Access Compliance Report Public Rights-of-Way (Curb Ramps)

Main Street: CEDARLAWN_DR Cross Street: PALM_DR Location: NE

ADA ID: RPAT210917103144 Ramp Type: Type 1 - Perpendicular Diagonal Initial Pass/Fail: Pass Overall Compliance: No Severity Score: 29

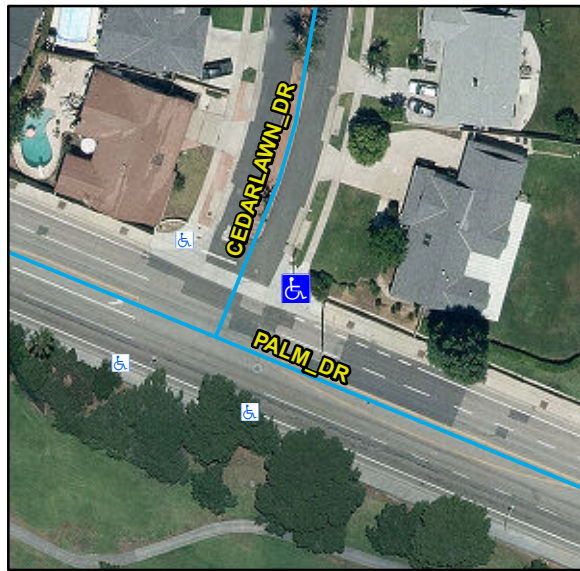
Compliance	Description	Data	Compliance	Description	Data
N/A	Ramp Length (in)	65	N/A	Flare Type LT	
Yes	Ramp Width (in)	48			Sloped
Yes	Ramp Run Slope (%)	7.1	No	Flare Slope LT (%)	12.3
No	Ramp Cross Slope (%)	5.5	N/A	Flare Traversable LT	Yes
N/A	Landing Present	Yes	N/A	Flare Type RT	
N/A	Landing Length (in)	40			Sloped
Yes	Landing Width (in)	48	Yes	Flare Slope RT (%)	0.8
Yes	Landing Run Slope (%)	0.3	N/A	Flare Traversable RT	Yes
No	Landing Cross Slope (%)	7.4	Yes	DWS Provided	Yes
N/A	Landing Movement Obstructed?	Yes	Yes	DWS Contrast	Yes
	Landing Movement Type	Curb	Yes	DWS Length (in)	36
N/A	Landing Shared	No	Yes	DWS Full Width	Yes
N/A	Clear Space	Yes	Yes	DWS Offset Left (in)	0
N/A	Clear Space To Crosswalk (in)	48	Yes	DWS Offset Right (in)	N/A
N/A	Marked Crosswalk 1	No	N/A	Marked Crosswalk 2	No
	Crossing 1 Direction	W		Crossing 2 Direction	S
	Marked Crosswalk 1 Width (in)	N/A		Marked Crosswalk 2 Width (in)	N/A

N/A	Ramp Inside Crosswalk 1	N/A	Yes	Ramp Inside Crosswalk 2	N/A
	Crossing 1 Slope (%)	0.9		Crossing 2 Slope (%)	8.2
	Crossing 1 Cross Slope (%)	6.9		Crossing 2 Cross Slope (%)	1.7
Yes	Gutter Ponding	No	No	Curb Slope	8.7
Yes	Gutter Lip Height (in)	0		Road Run Slope (%)	6.7
Yes	Gutter Run Slope (%)	1.1		Road Cross Slope (%)	5.8
No	Gutter Cross Slope (%)	6.5			
Yes	Overall Surface Condition: Acceptable		Yes	Perp Joint Present	Yes
	Cross Gutter Present?	Yes		Spandrel Present?	Yes
	Replace Cross Gutter?	No		Replace Spandrel?	No

Remove & Replace Curb Ramp With Two New Directional Ramps or Equivalent. Remove & Replace Gutter.
